# UNITED STATES PATENT AND TRADEMARK OFFICE

APPLICATION NO.	FILING DATE	FIRST NAMED INVENTOR	ATTORNEY DOCKET NO.	CONFIRMATION NO.
10/552,583	10/12/2005	Denis Roller	125402	2540

<b>Office Action Summary</b>	<b>Application No.</b> 10/552,583	<b>Applicant(s)</b> ROLLER ET AL.	
	<b>Examiner</b> Benjamin P. Lee	<b>Art Unit</b> 3641

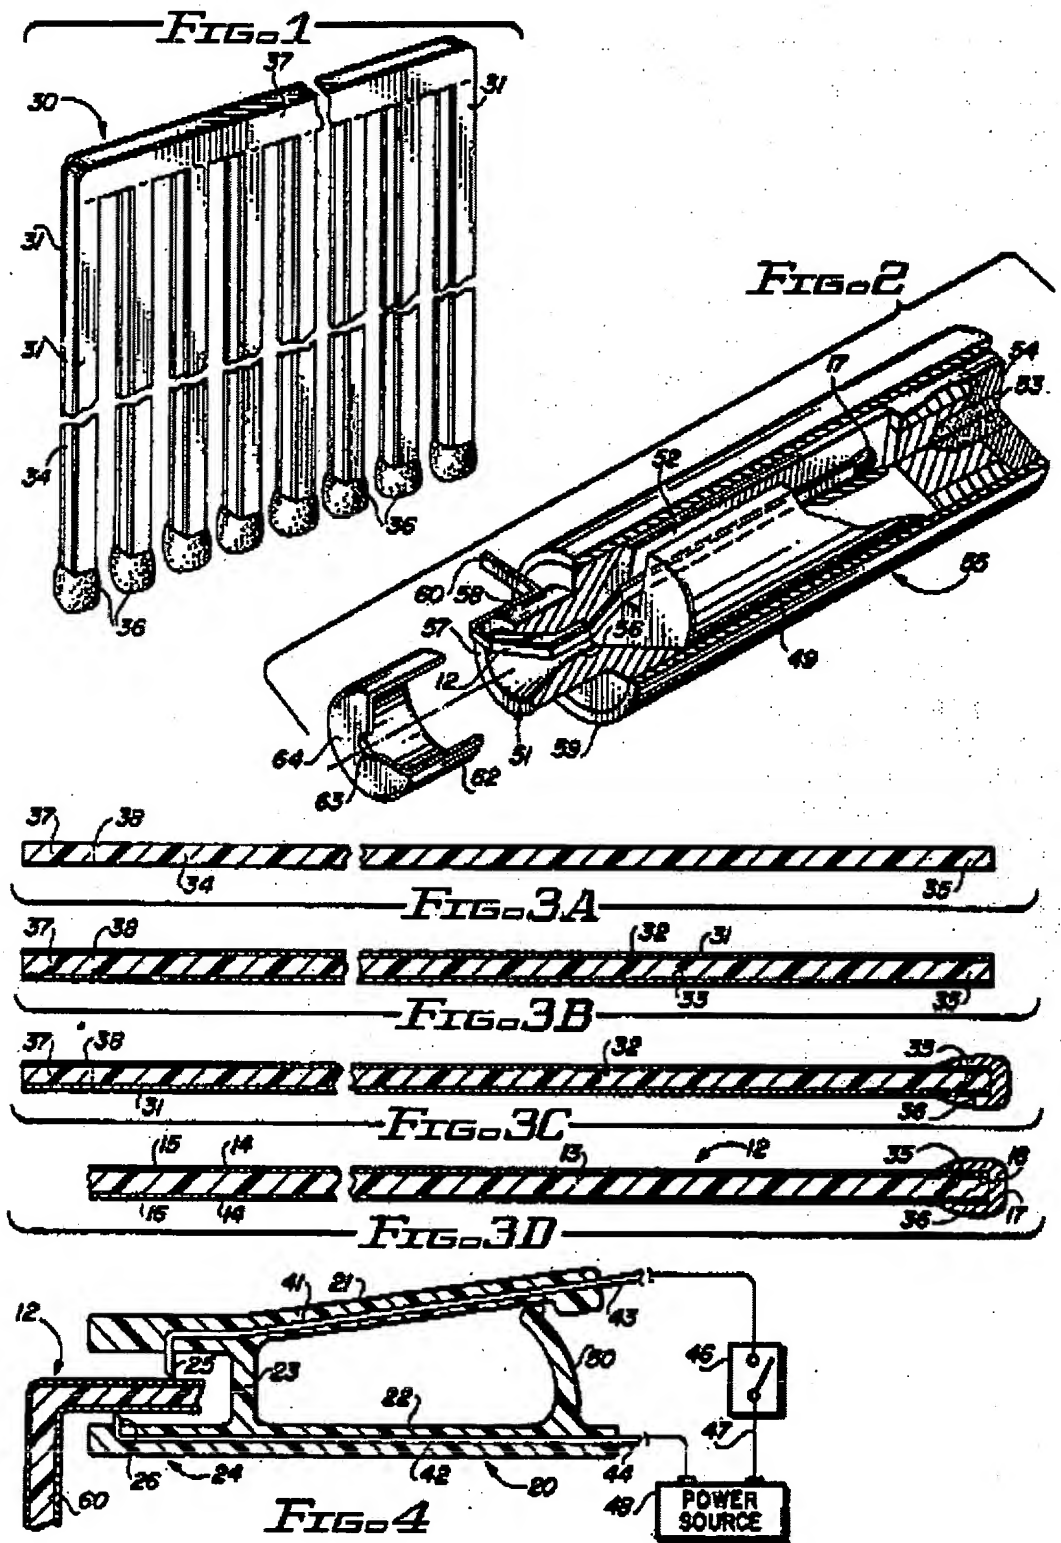
3. Claims 1-4, 7, 8, 10-13 and 17 are rejected under 35 U.S.C. 102(b) as being anticipated by Hans et al. (U.S. Patent 5123355).
4. In regards to claim 1, Hans et al disclose the following:
  - a. a device for the electrical initiation of at least one pyrotechnic microcharge  
(item 17 of fig. 3D following and col. 2, lines 39-52);
  - b. a support element having at least one electrically conductive portion

connected to a first terminal of a central control unit (item 21 of fig. 4 following);

- c. a second terminal of said central control unit being intended to be electrically connected to an electrically conductive support (item 12 of fig. 4 and 3D following and col. 3, lines 54-58);
- d. the microcharge being located at a sufficient distance from said conductive support to be able to be ignited by localized heating of the support (col. 4, lines 50-64);
- e. heating being carried out via the conductive portion placed in contact with the conductive support, just beneath the pyrotechnic microcharge (col. 4, lines 50-64 and see fig. 3D following).

5. In regards to claim 2, Hans et al disclose that the pyrotechnic microcharge is deposited on the conductive support (see fig. 3D following).

7. In regards to claim 4, Hans et al disclose that the conductive portion is produced at least at the top of a finger (item 25 of fig. 4 following) being positioned so as to bear via its top against the conductive support (see fig. 4 following).

8. In regards to claim 7, Hans et al disclose that the finger consists of a boss made of flexible material formed on the support element (item 25 as shown in fig. 4 following constitutes “a small projection” as “Boss” is defined by [www.dictionary.com](http://www.dictionary.com) and item 41 is disclosed as “wire” which is inherently “flexible”).

9. In regards to claim 8, disclose that the support element consists of a thermoformed sheet of flexible material in which said boss is formed, the boss forming a finger intended to bear via its top against the conductive support (col. 3, lines 48-55). Note that the “support element” (item 21 of fig. 4 following) is disclosed by Hans et al to consist of “pliable plastic” which is inherently produced using a thermoforming method and item 21 constitutes a “sheet” to the degree specified by applicant.

12. In regards to claim 12, Hans et al disclose that the pyrotechnic microcharge is deposited on a face of the conductive layer and in that the conductive portion is in contact with the face of the conductive layer on the opposite side to that on which the pyrotechnic microcharge is deposited (col. 3, lines 40-47 and see figs. 4 and 3D followng).

14. In regards to claim 17, Hans et al disclose that it is produced by assembling superposed layers. Note that each igniter (item 12 of fig. 4 following) is constructed of a plastic film body "layer" with a foil overlay constituting "assembling superposed layers" (col. 3, lines 40-45).
